School District of Mishicot
Notice of Board of Education Meeting
Monday, September 28, 2026
Regular Meeting
High School Library
660 Washington Street
Mishicot, Wisconsin 54228
5:30 PM

RE: Mishicot MS/HS Additions and Renovations
Change Request

Project Title:
Addition & Renovation to
Mishicot Middle & High School
Mishicot School District
650 Washington Street
Mishicot, WI 54228

3.) 109B PRINCIPAL

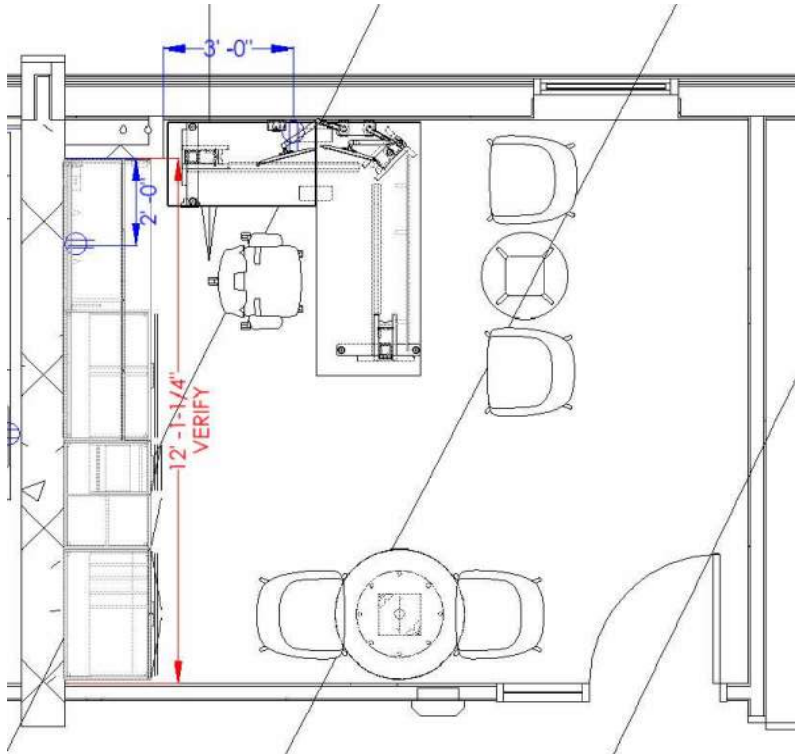
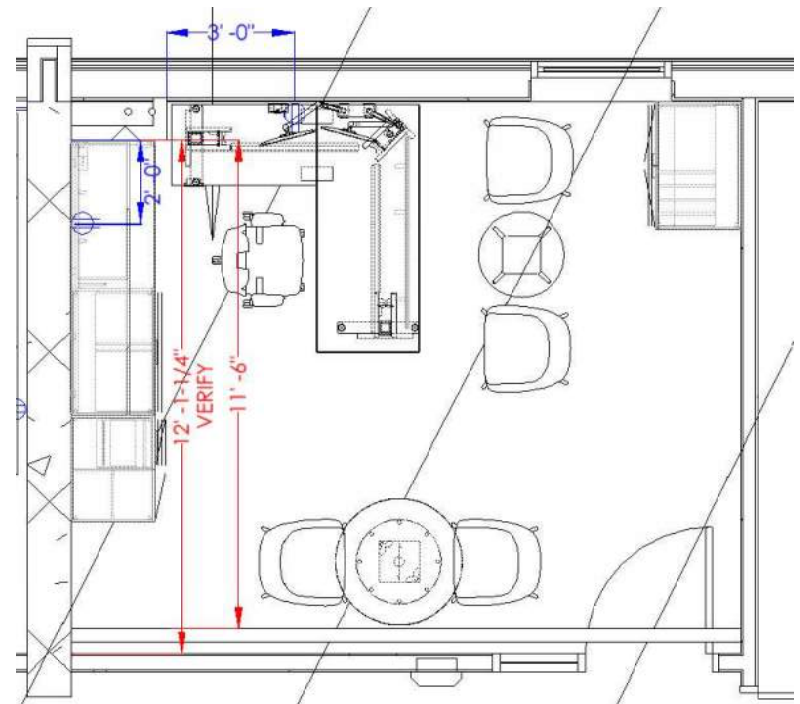
- Wall to column is 7" off from what plan showed. Plan was 12'-1" and site was 11'-6".

District to work with proposed solution of moving storage piece to East wall and test it out.

CJ&A to provide pricing to replace unit with one that will fit as secondary option - JS 7/23/26

4.) 202A LIBRARY CIRCULATION DESK

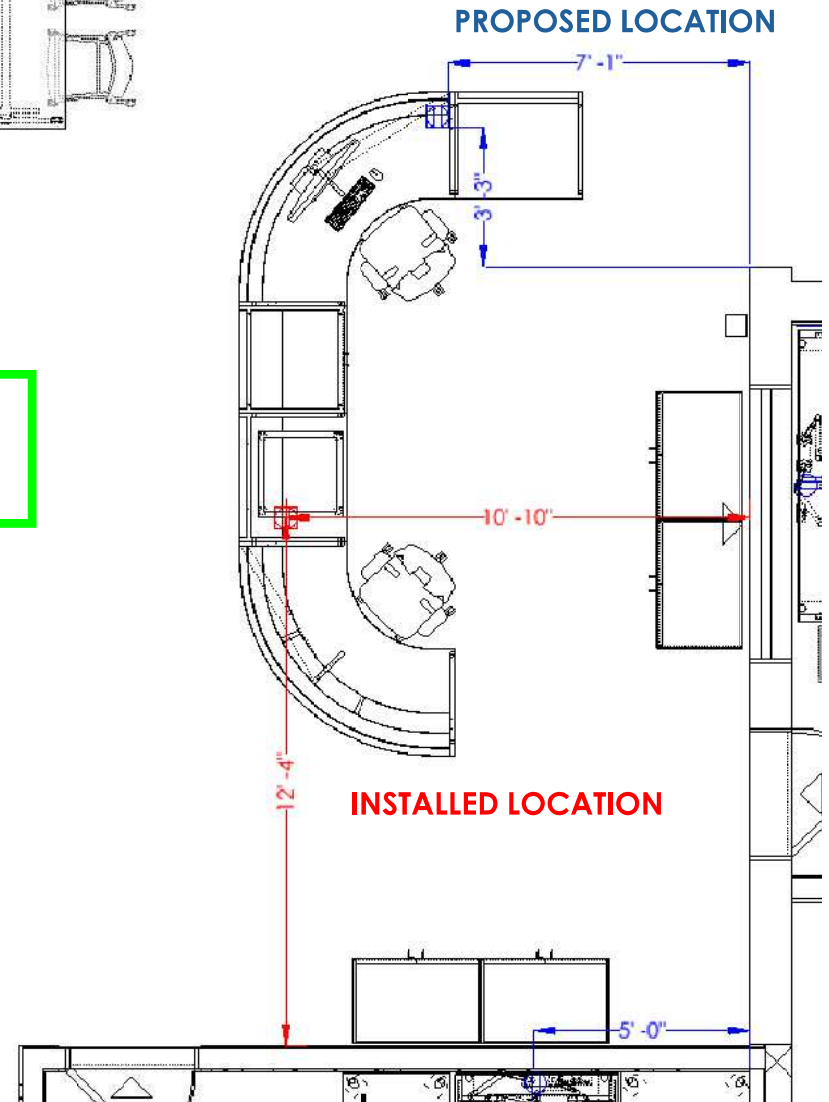
- Floor core placed in different location then planned.

Installed conditions to remain, no
change to current construction. - JS
7/23/26

4.) 202A LIBRARY

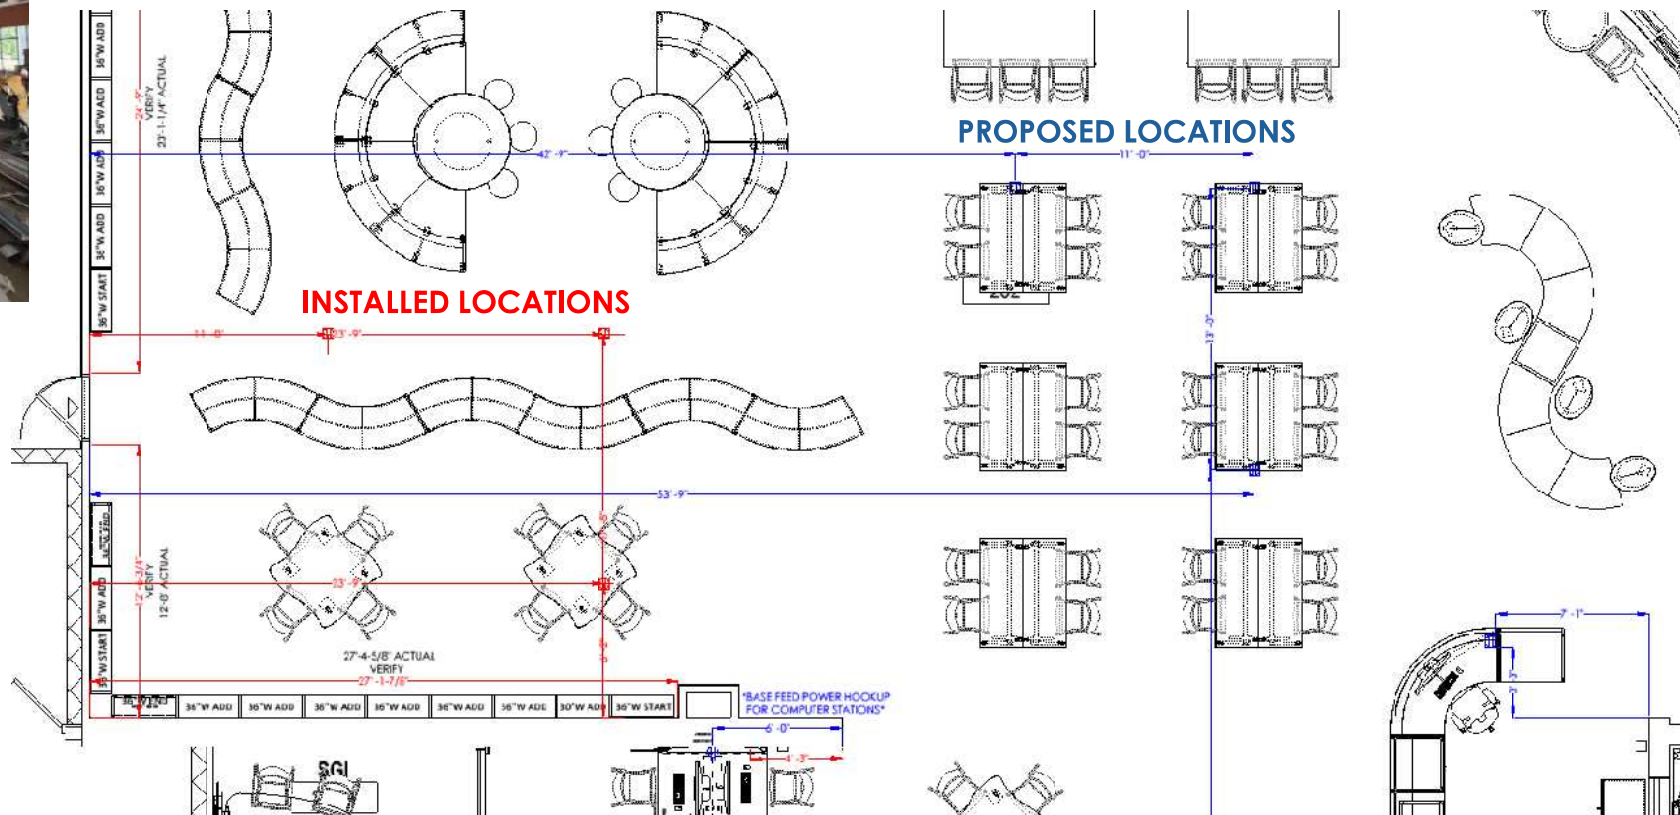
- Floor core placed in different location then planned.

Installed locations to remain, no changes to construction.
JSC/Hubbart/MSD reviewed and confirmed location of outlet
in 202F is acceptable. - JS 7/23/26

Elevation B

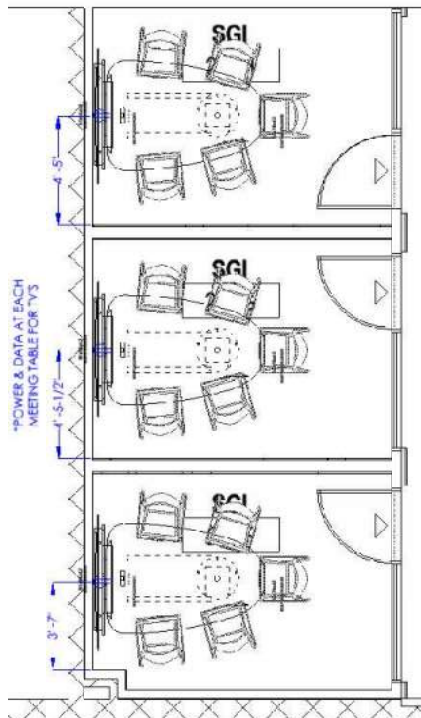
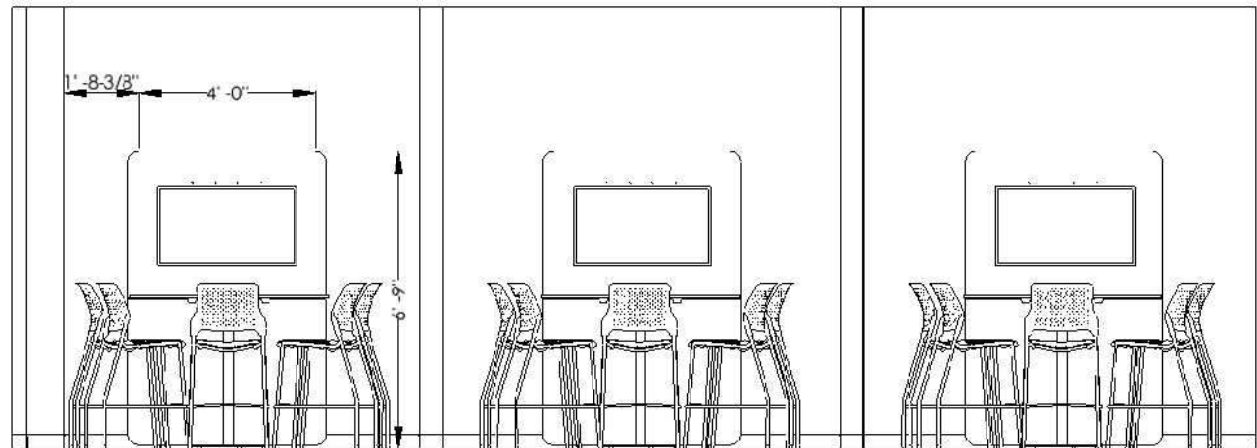
Power/Data locations are off center. The media walls should be able to make this work and conceal the wiring.
Main concern is with room 202F as that one is the furthest off center. Verify dimensions.

6.) 202A LIBRARY COMPUTER TABLES

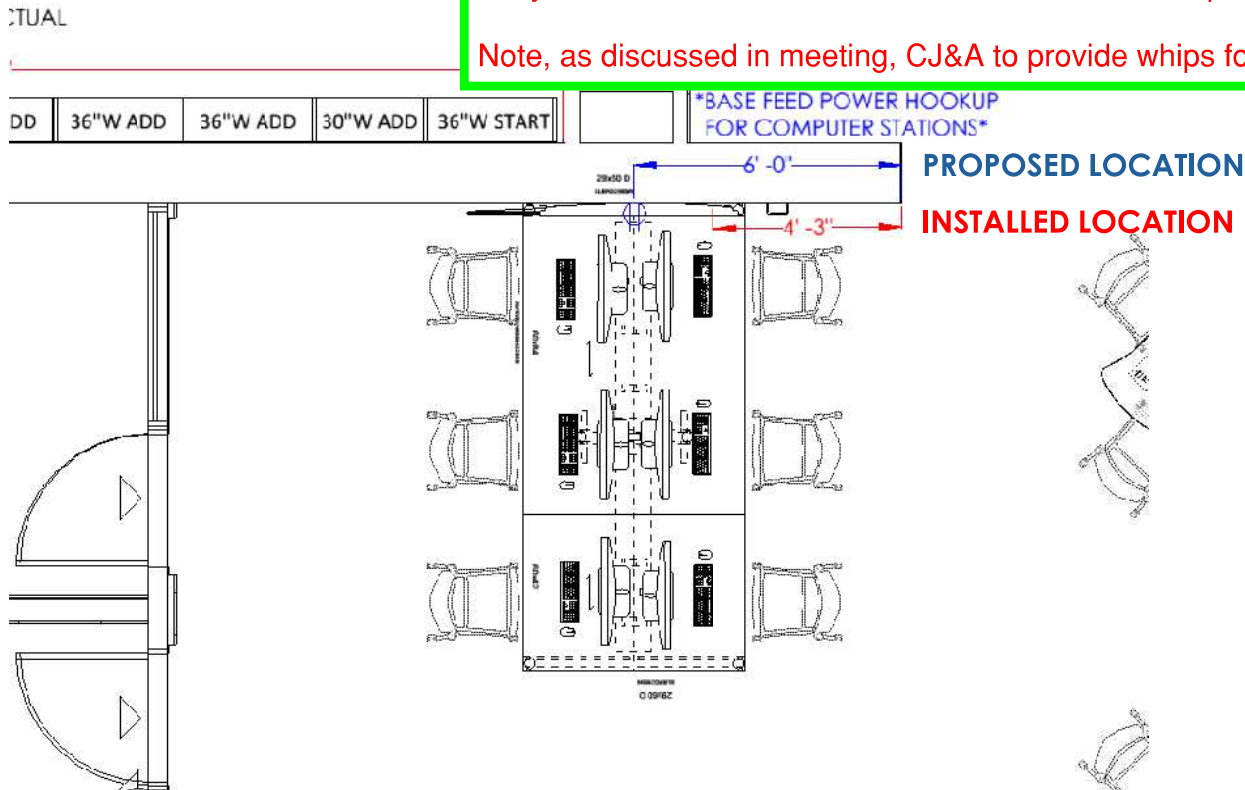
- No furniture feed whip planned here. Currently opening for standard receptacle outlet.

- Add power box for furniture whip in place of the standard outlet. Placement will be fine, as it will fall behind the leg of the desks. Once furniture is on site, electrical can hook up whip.

Per discussions onsite with Aaron of MSD, he is goign to confirm electrical and power needs at this location. Will likely look to add additional outlet and additional data ports at this location. - JS 7/23/26

Note, as discussed in meeting, CJ&A to provide whips for installation by EC. - JS 7/23/26
